**New Folder Name** Crane Hook Height in the  
LVEA and VEAS

T950048

Subject: Crane hook height in the LVEA and VEAs

Subject: LIGO-T950048-00-0 (Crane hook height in LVEA/VEA)

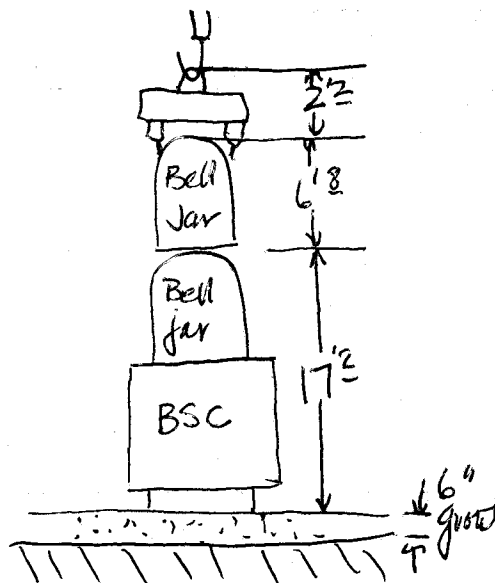
Thanks for sharing this issue with us. Your dimensions appear to be sound. Nonetheless, I'd like to take issue with some of your assumptions.

First, I should admit I am ignorant about the cost delta per foot of crane hook height. In the trade study documentation the issue appears to have been glossed over; was there any resolution eventually? It seems this should be the starting point for optimization. Although it's clear the lower the cheaper (zero being cheapest), I do not understand how a potential penalty in function can be accepted without even a rough idea of the balancing cost benefit.

Second, the roof height is a qualitatively different parameter than the building footprint, in the sense that expansion vertically essentially amounts to rebuilding the structure. (I have heard proposals for local pop-ups or cutouts, and in my opinion they appear less workable than rebuilding). I would therefore argue that crane hook height belongs more to the set of permanent, immovable facility constraints, along with such parameters as beam tube outgassing, tube baffles, and site vibration, than to the set of "initial" parameters, such as the station floorplan or footprint.

In all other cases where a fundamental facility constraint is encountered, a suitable contingency allowance has been made and documented. This has not been done for the hook height, partly because a particular piece of hardware (the TMC) was consistently linked to that dimension in the past (erroneously, I feel). While a preliminary analysis of one future seismic isolation scenario appeared to vindicate the BSC envelope (ref. Sievers and Li), this was a very narrow and highly conceptual sample of future configuration space, and I feel it should not be taken as representative. If the BSC had NOT proven large enough for this potential future variant, we would have considered it a serious problem; this possibility drove us to check it out.

Given the current state of affairs, there may be no way to make a cogent study of future interferometer possibilities and their sensitivities to building height in time for a reasoned strategy to emerge. I would therefore plead that we at least include some proportional contingency margin, over and above the absolute minimum dictated by the initial vacuum equipment. This is consistent with our approach to other permanent facility constraints (for example, beam tube baffles) in which uncertainty about the future state of the art defeats a closed solution. For a feature of this importance, adding 20% does not seem unreasonable.

- The working requirement is that a BSC bell jar should be able to be removed from a fully-loaded BSC. For this exercise, I used the requirement that a BSC bell jar be able to be lifted over a BSC with the bell jar attached. This gives a small safety factor of the thickness of the wall of the bell jar.

- Chamber dimensions, taken from the vacuum equipment RFP drawings, are: BSC height = 17'2", BSC bell jar height = 6'8".
- Allowance for chamber installation grouting (includes 2" change in floor height due to curvature of earth) = 6".

- Height of lifting fixture (spreader bar) = 2'2". Based on a 12" deep I-beam, with 2" deep tabs below and 6" for shackles to attach to the chambers, and 6" above for an eye through which the crane hook passes. This fixture design was discussed with J. Worden, O. Matherny and a rigging expert from Parsons, Mike McKenna. M. McKenna felt that the 2'2" for the lifting fixture was conservative, and that the height of a carefully-designed fixture might be as little as 1'4".

The total minimum hook height is thus  $17'2" + 6'8" + 6" + 2'2" = 26'6"$ .
